Re: Bayer MaterialScience LLC
125 New South Road – Hicksville, New York
ICM Work Plan Modification
USEPA ID#: NYD002920312
BBL Project #: 2302.32303 #5

On behalf of Bayer MaterialScience LLC (Bayer), this letter modifies the *Interim Corrective Measure Work Plan* (the ICM Work Plan) prepared by Blasland, Bouck & Lee, Inc. (BBL, June 2004) for the Bayer site located in Hicksville, New York. The modification is being submitted in response to the New York State Department of Environmental Conservation's (NYSDEC's) comments included with your e-mail correspondence dated April 25, 2005. For ease of presentation, each NYSDEC comment is presented below, followed by Bayer's response.

REPORT

*Interim Corrective Measure
Work Plan*

**PROPOSED SUBSURFACE STRUCTURE
 CLEANING LOCATIONS**

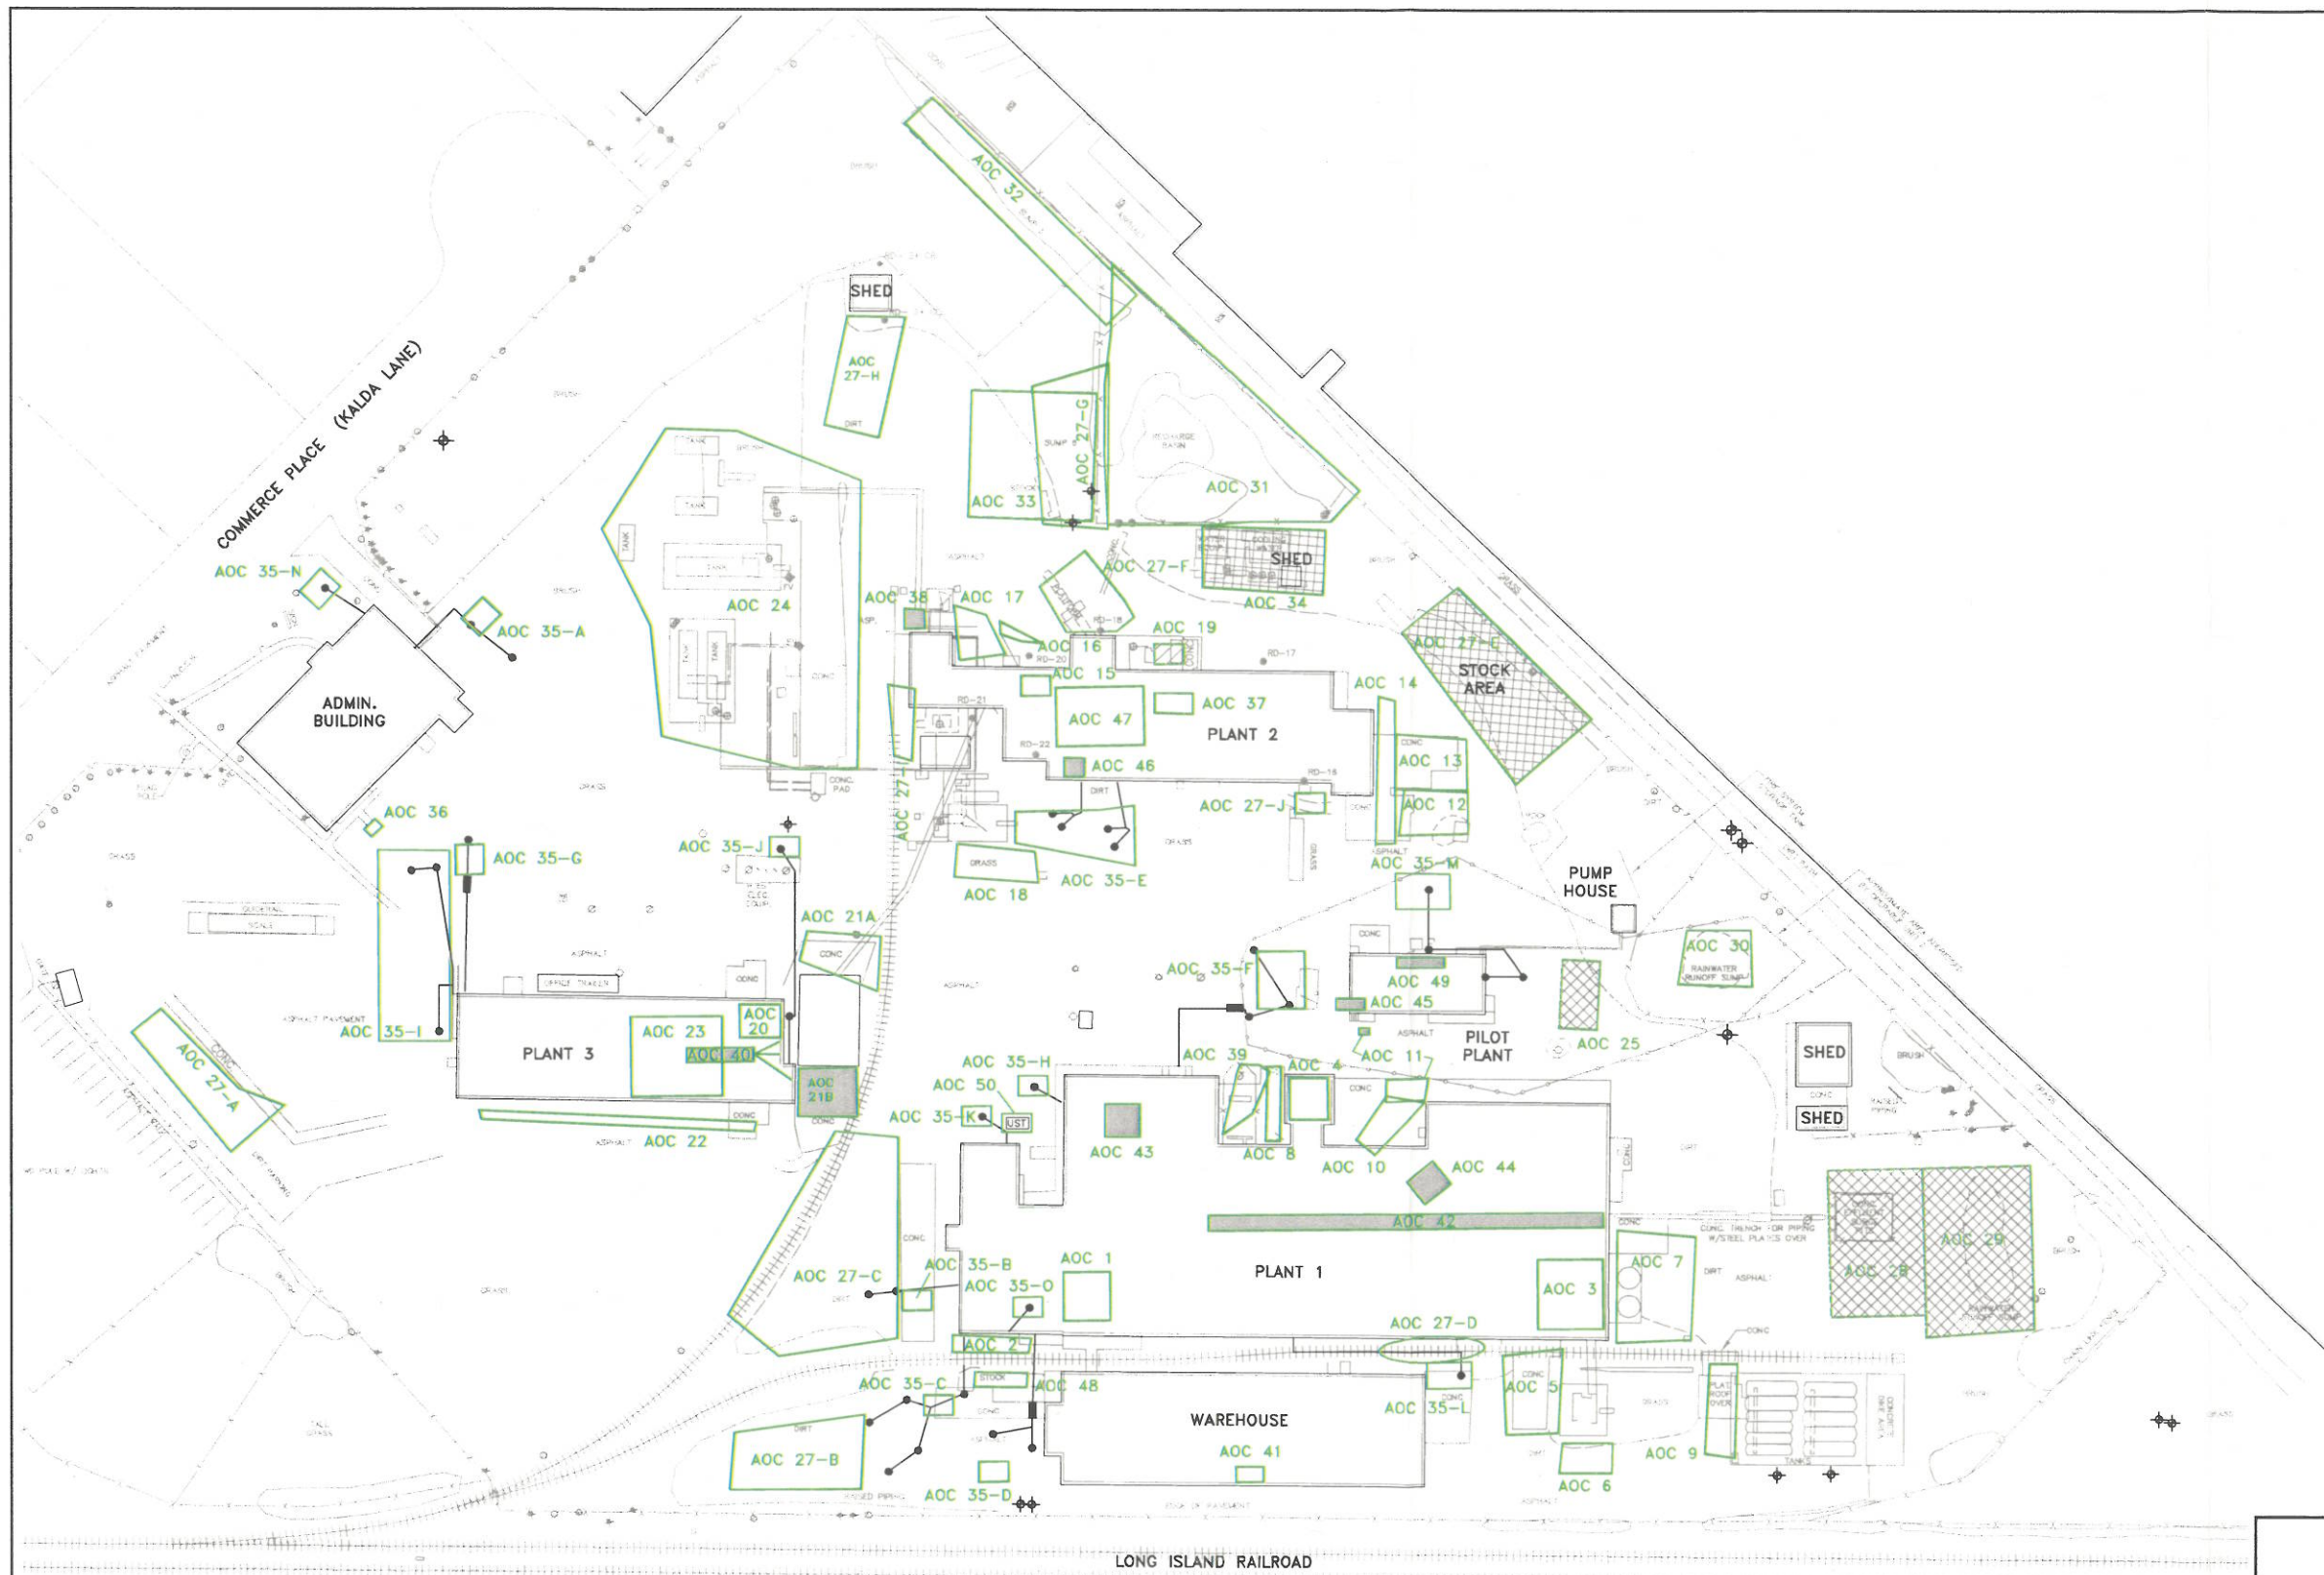
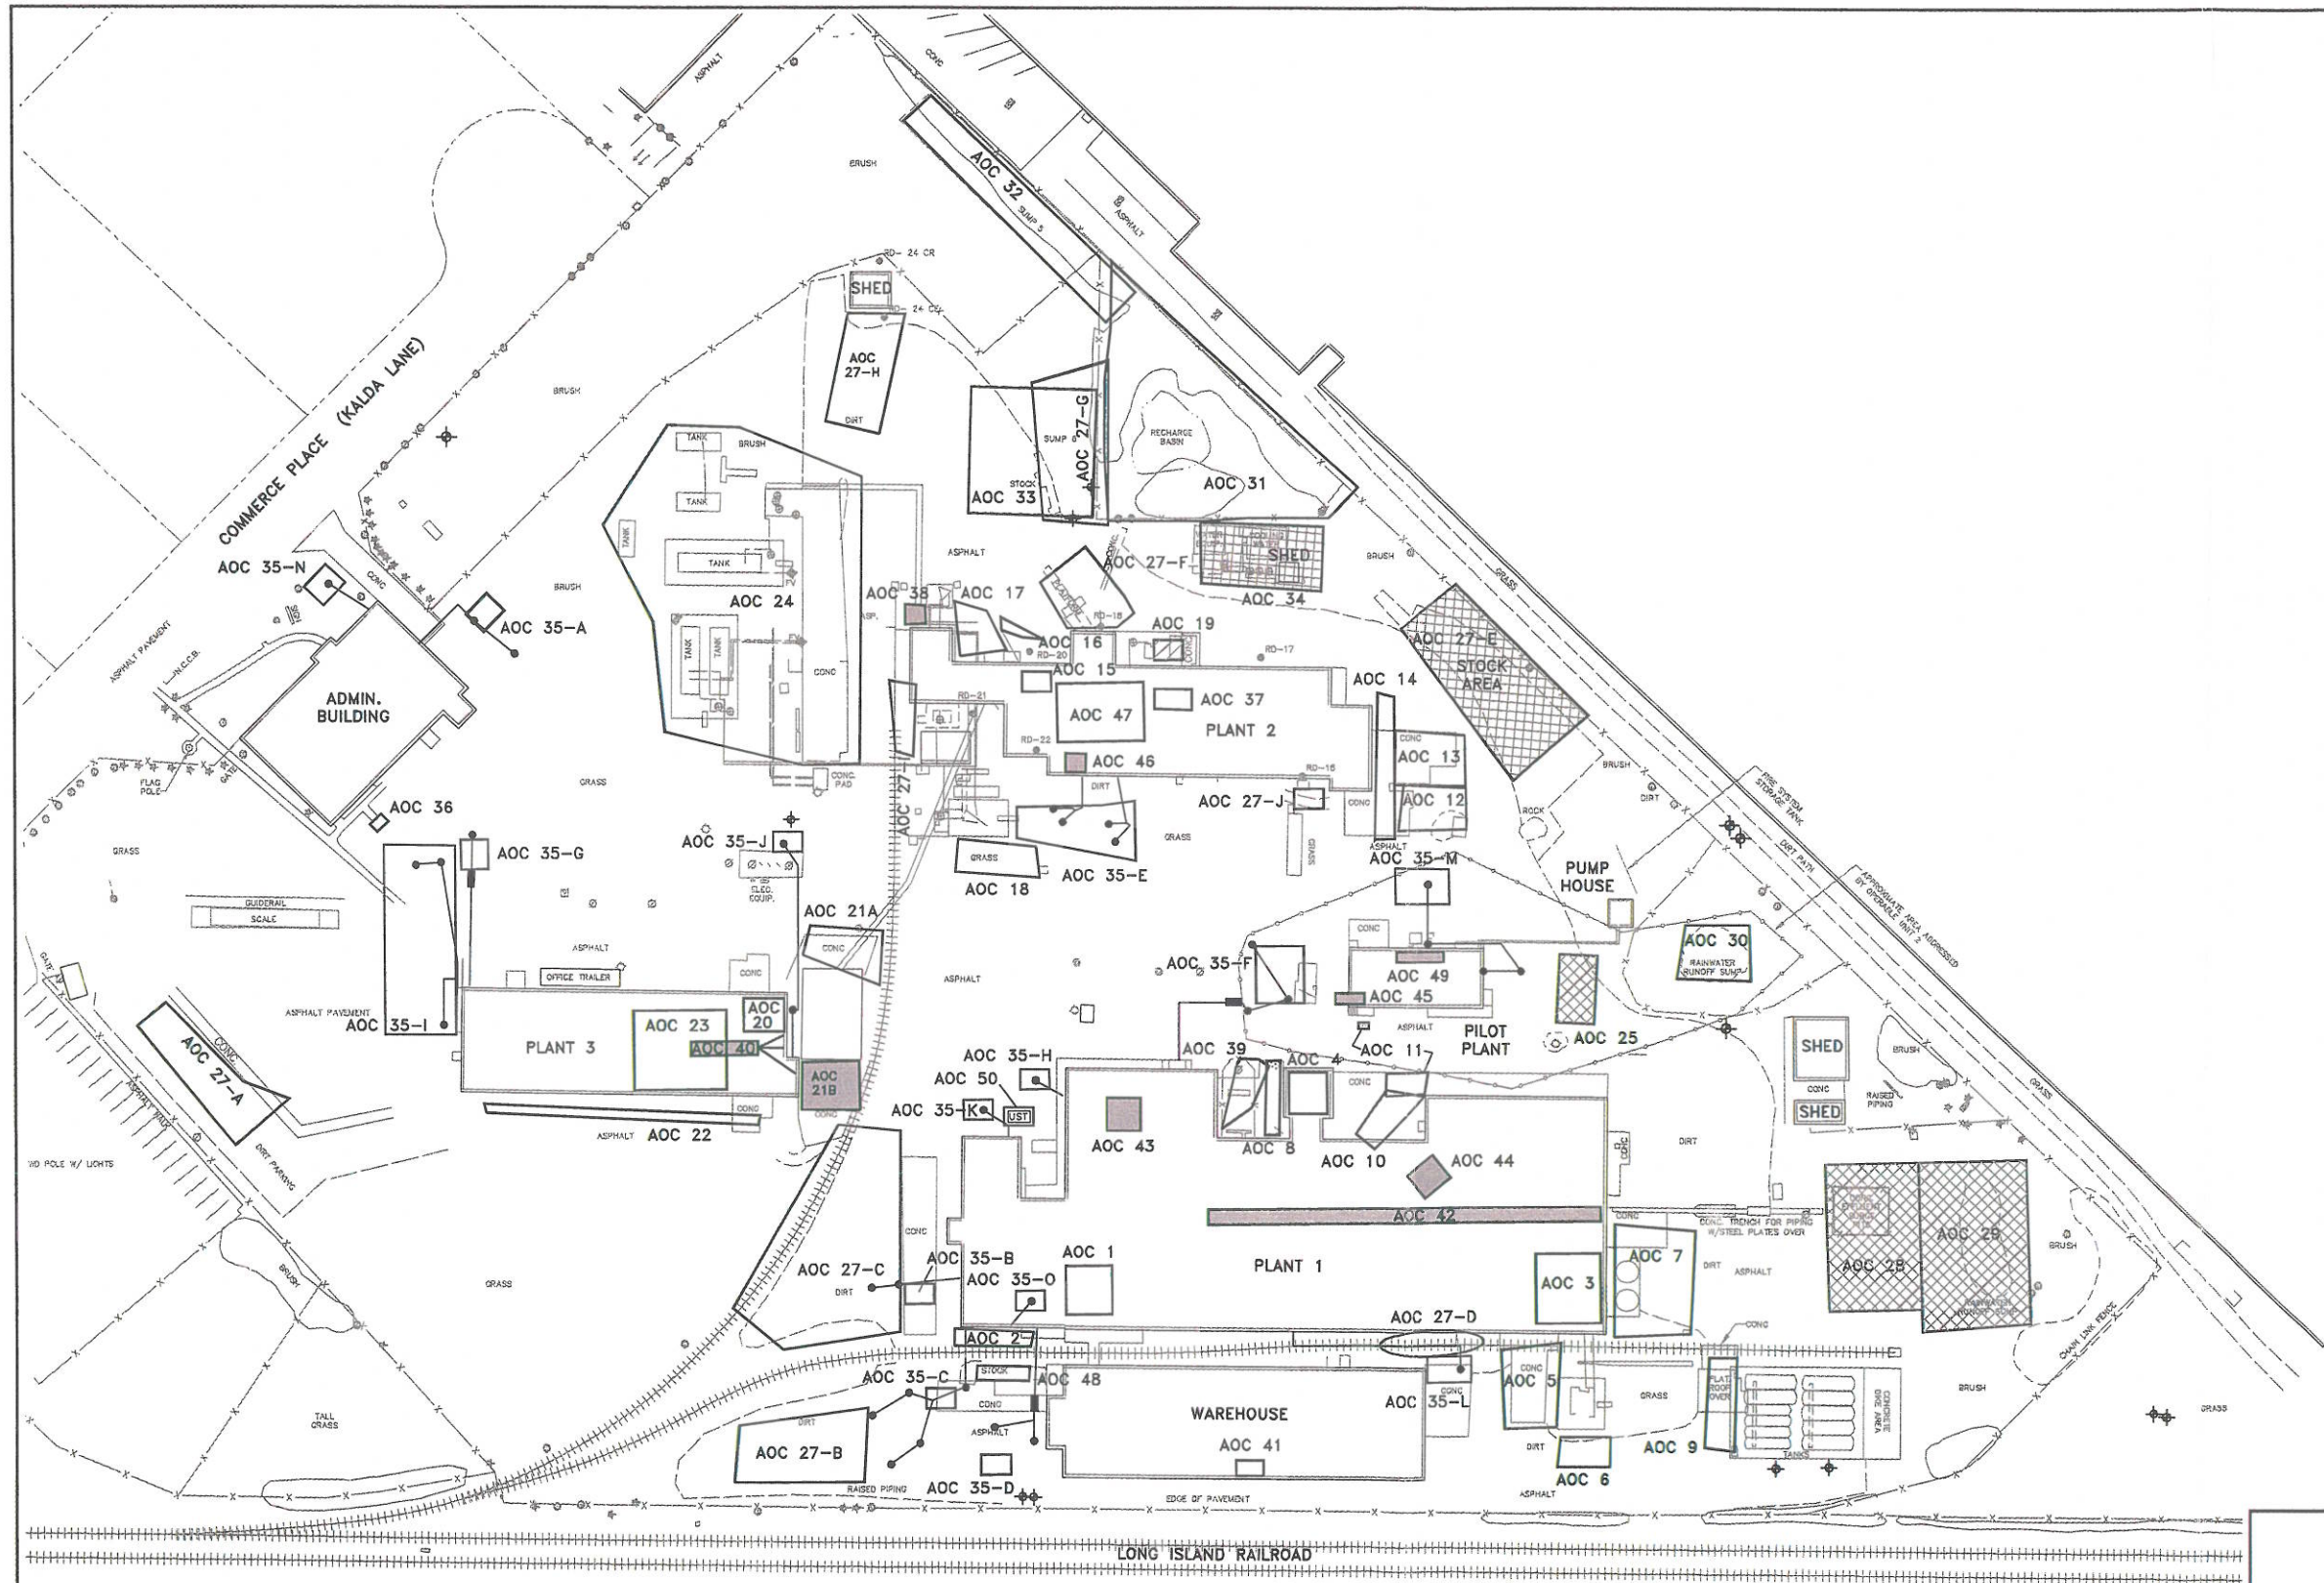
Comment 5

According to the work plan, a visual inspection of the interior surfaces of each selected subsurface structure will be conducted after water and debris removal. The structure cleaning will be considered completed based on visual inspection by an onsite BBL representative. Explain specifically what the visual inspection will look for, other than any remaining debris in the structures. Also clarify if the results of the visual inspection will be documented.

Besides being performed to look for any debris remaining in the subsurface structures, the visual inspection of each structure will also be performed to look for any heavy staining or large cracks in the walls/bottom that might suggest potential impacts to underlying soils. If heavy staining and cracks are observed in a structure, the NYSDEC will be contacted to discuss any further actions that may be needed.

Photographs will be taken to document the condition of each structure following cleaning. Results of the visual inspections (including photograph number) will be documented in the field notebook.
